# CITY OF ALBUQUERQUE

RE: 4917 Tally Ho

Grading and Drainage Plan Engineer's Stamp Date: 6/7/22 Hydrology File: A12D033

Based upon the information provided in your submittal received 6/6/22, the Grading & Drainage Plan **is not** approved for Building Permit. The following comments need to be addressed for approval of the above referenced project:

GRADING AND DRAINAGE PLAN

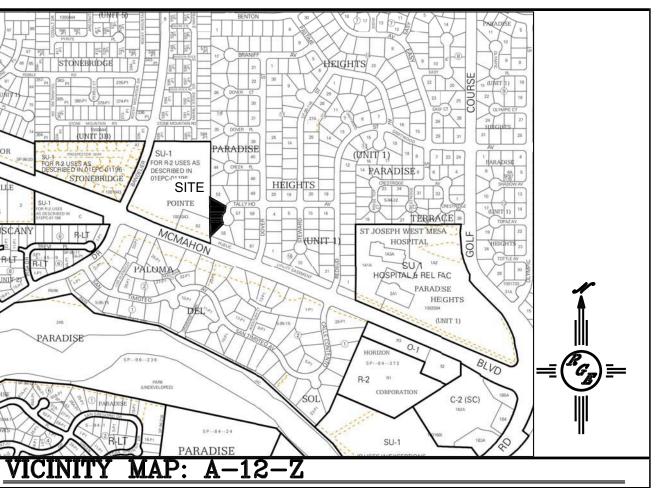
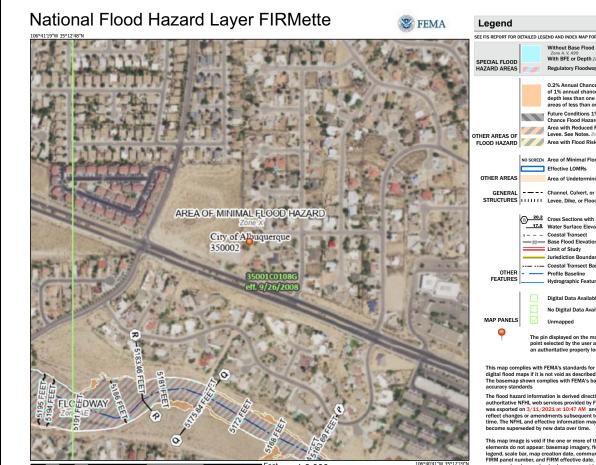
- 1. Please update the engineer stamp date. Submittal date is before stamp date.
- 2. For pool and hot tub -Show concrete area (hatch if needed) to clearly define what is impervious and part of this pool install. (deck included).
  - a. Include spot elevations at corners of pool and pool deck.
- 3. Please show distance from structures and any walls.
- 4. Clearly define what is being constructed on this plan.

a. I cannot tell if it is simply the pool or is the concrete also being added? Was the concrete part of a previous G&D?
